EPC STORMWATER REVIEW COMMENTS
IN ORANGE BOXES WITH BLACK TEXT

VOLLMER ROAD (NORTH)

STREET IMPROVEMENT PLAN

FEBRUARY 2023

**DP01 PROFILE
STA 0+00.00 TO 2+55.94**

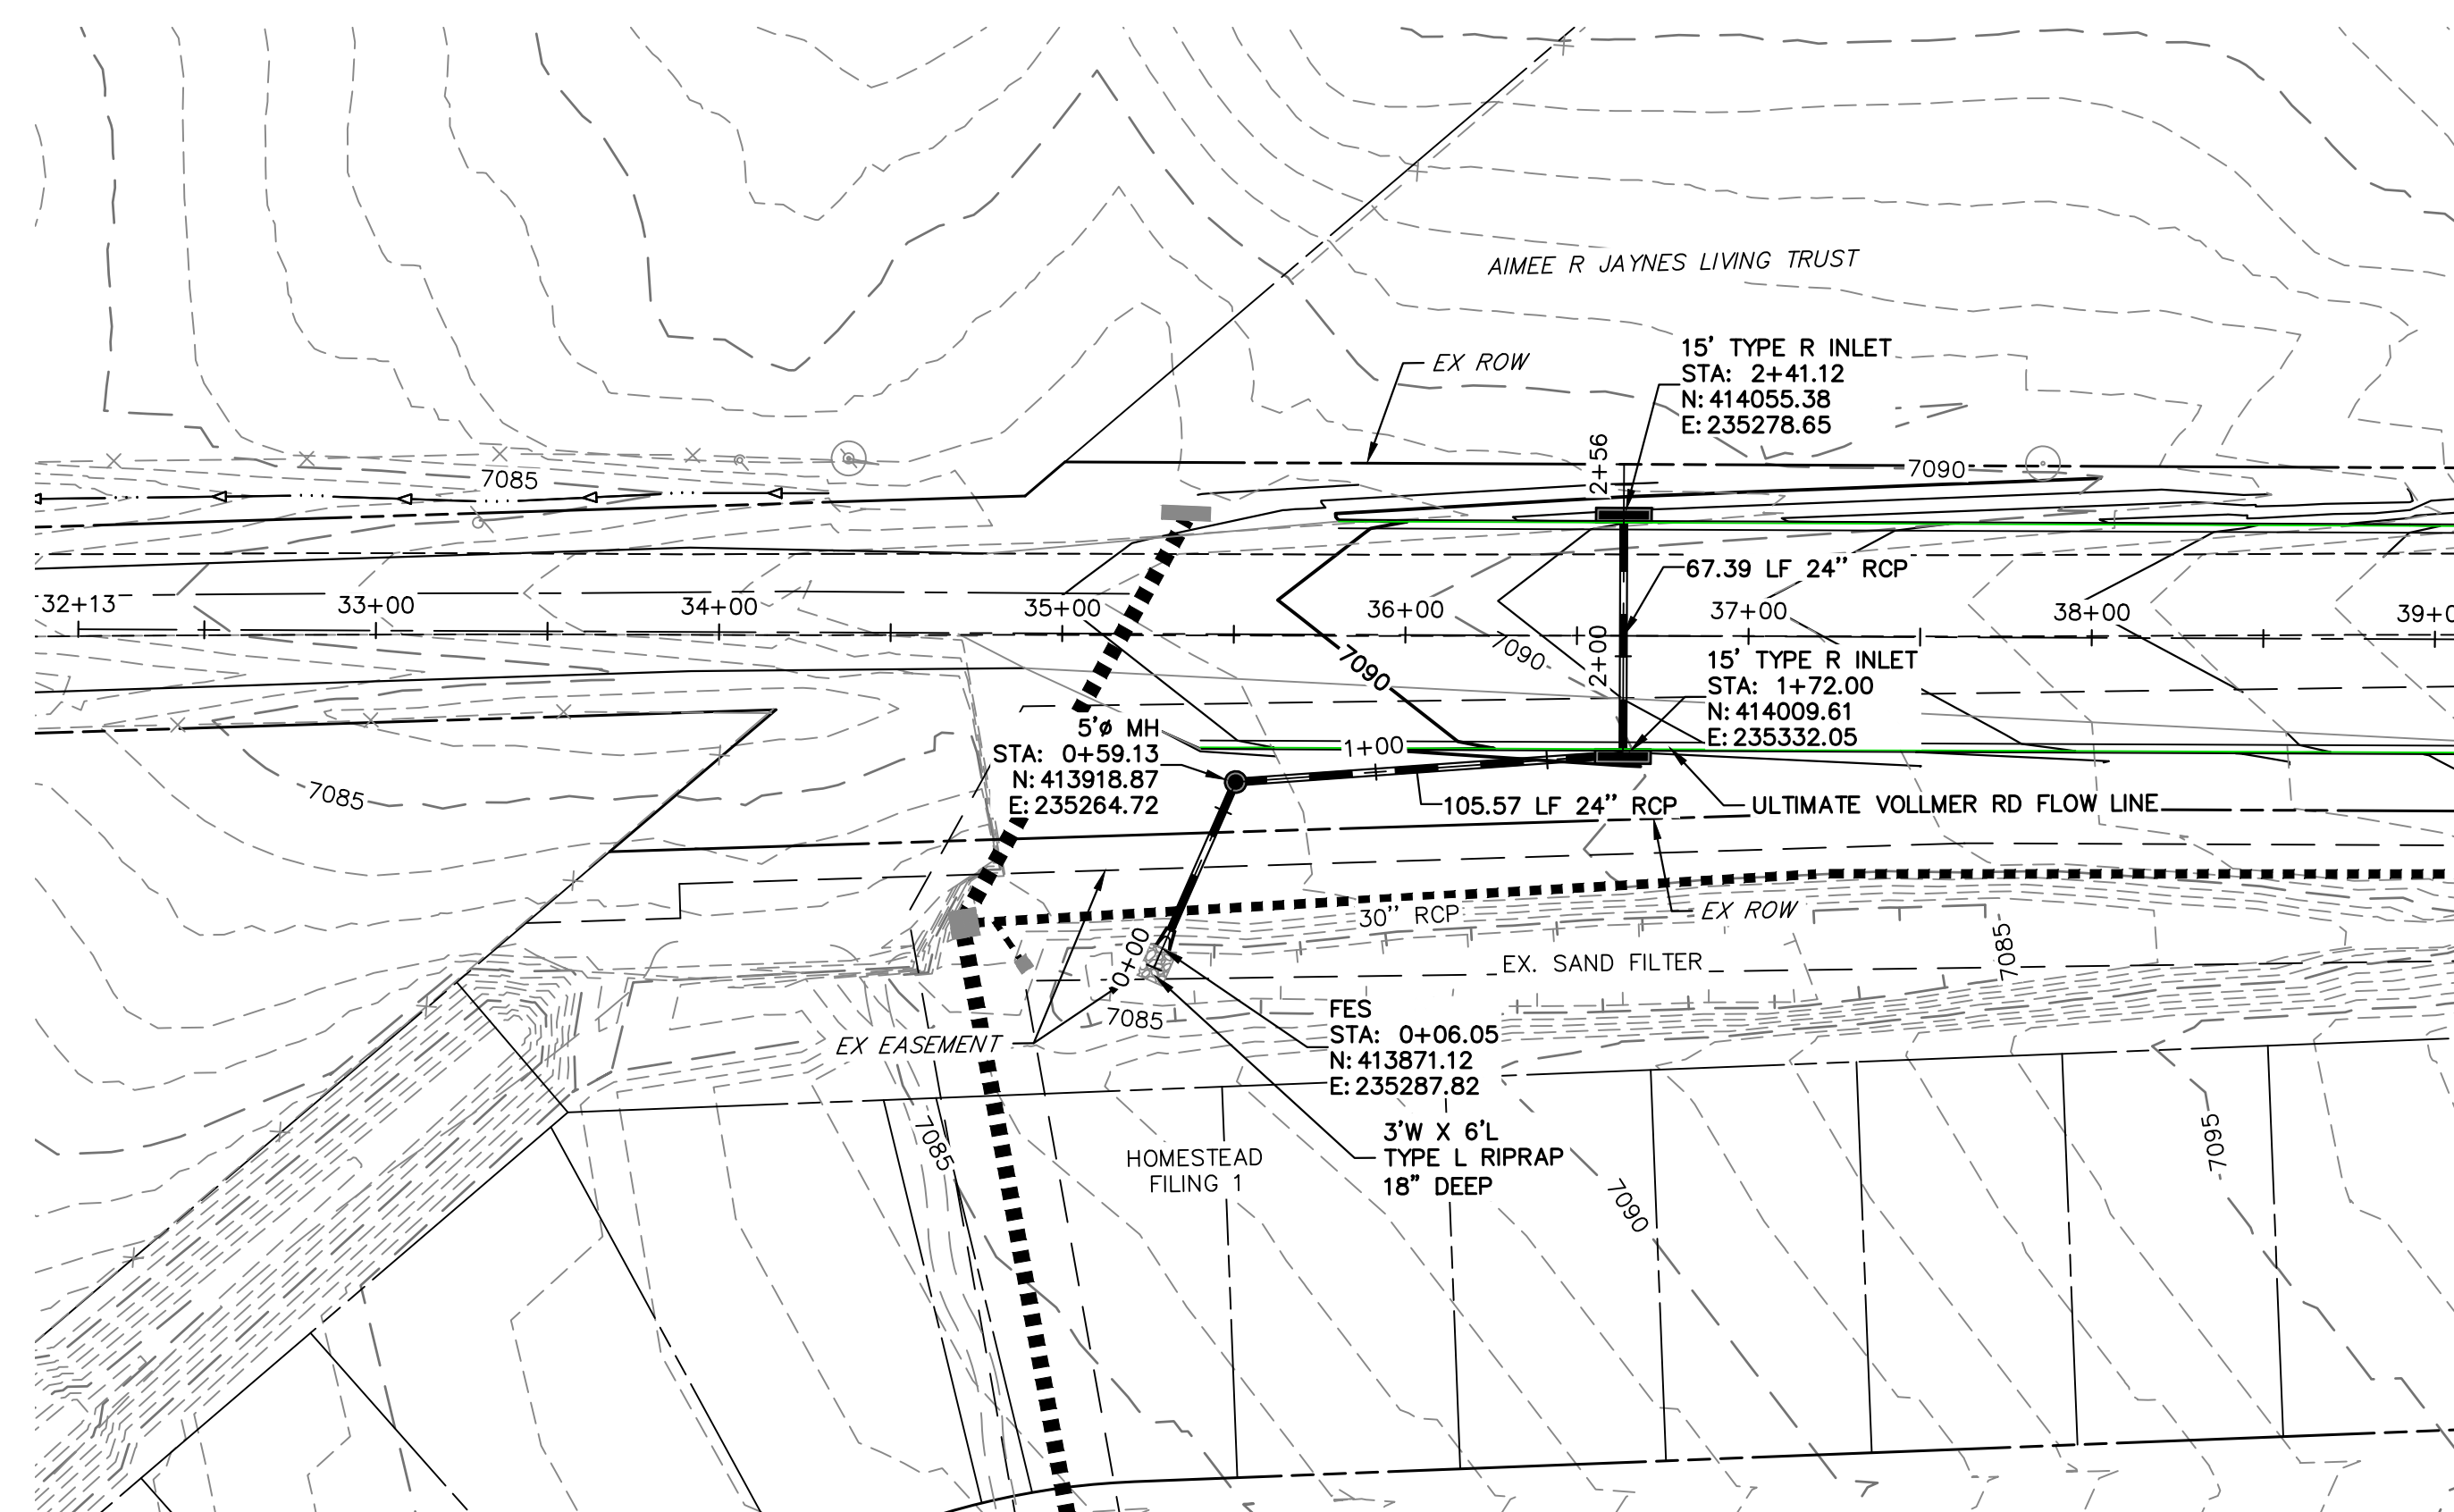
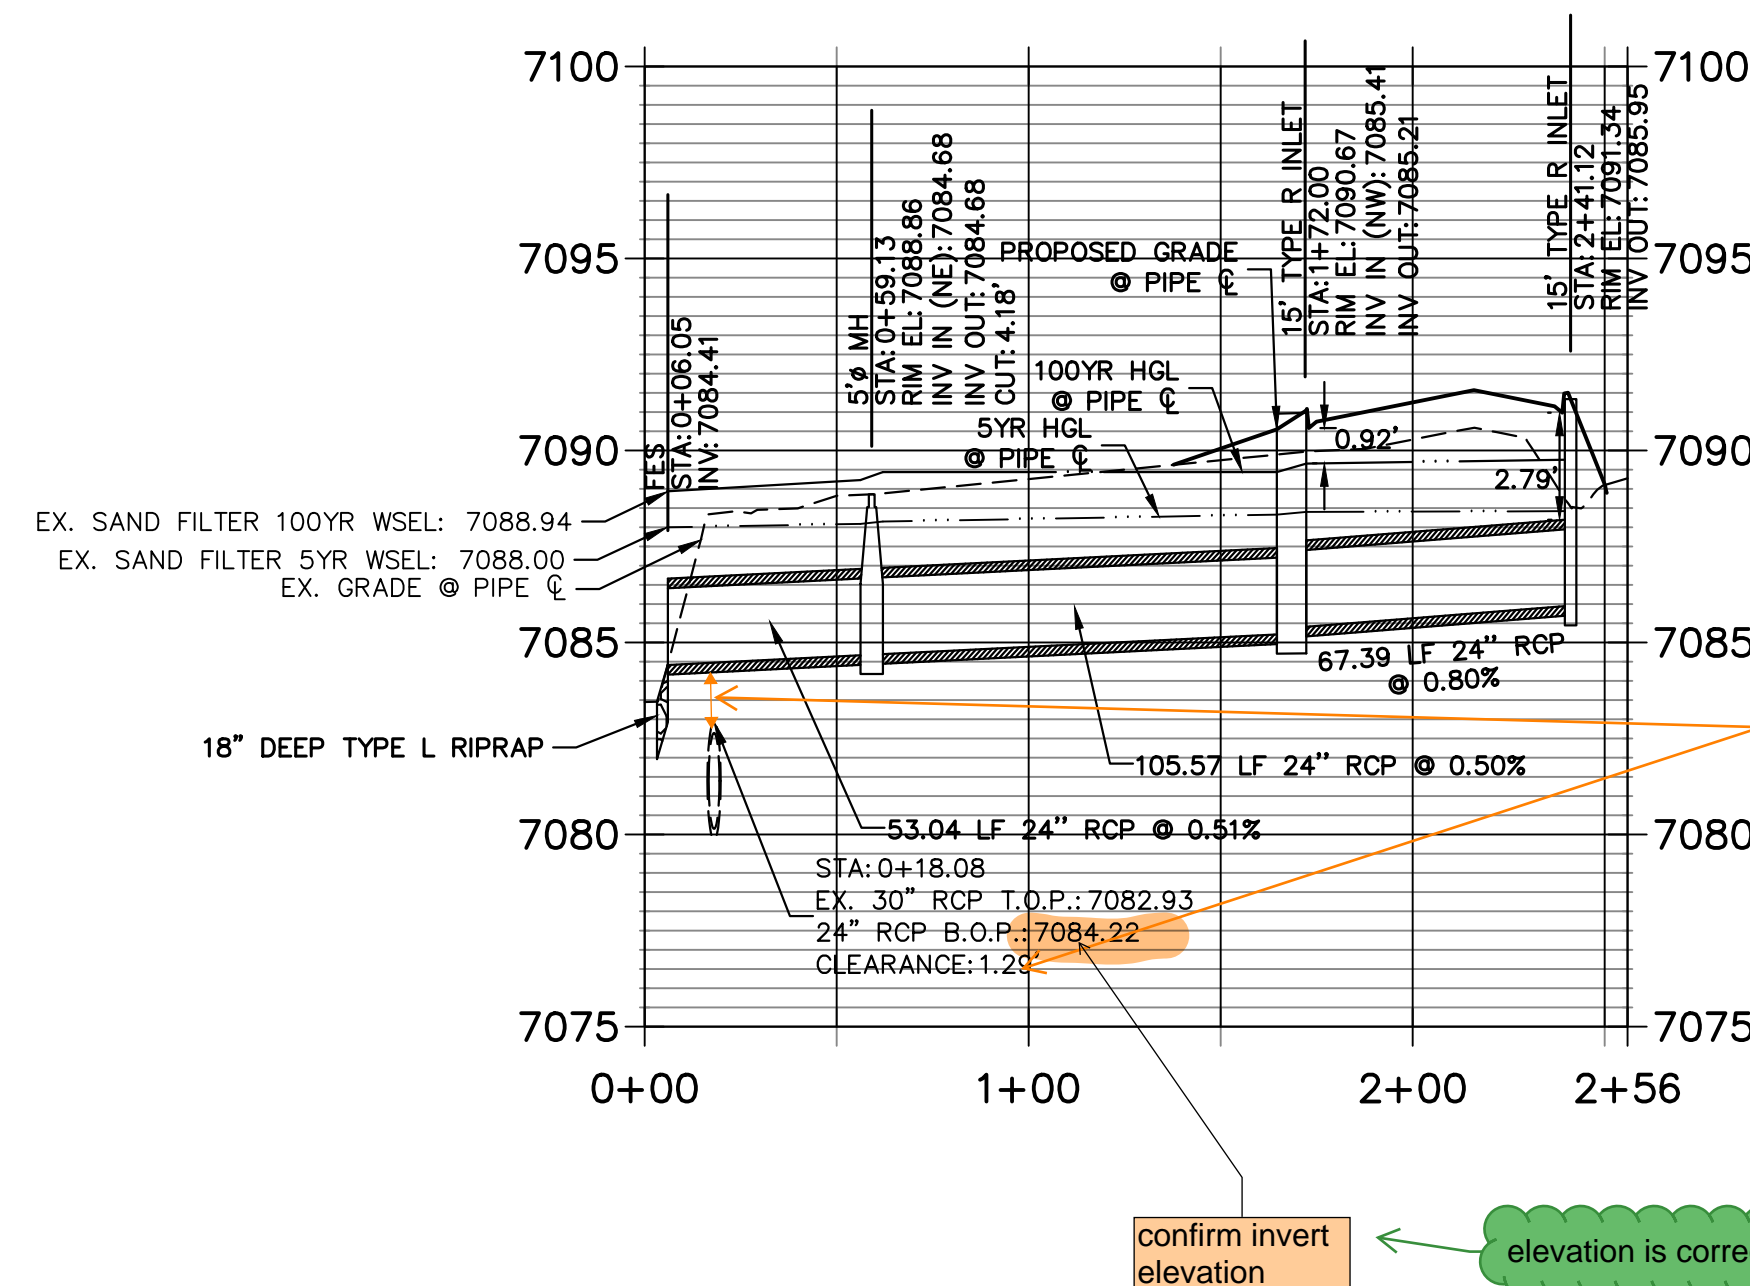
pipe thickness is included in this clearance

Verify the pipe thickness is included in this clearance distance provided.

confirm invert elevation ← elevation is correct

ADD WATER TIGHT JOINT WHEN 100 YR HGL SHOWS PIPE FULLY INUNDATED
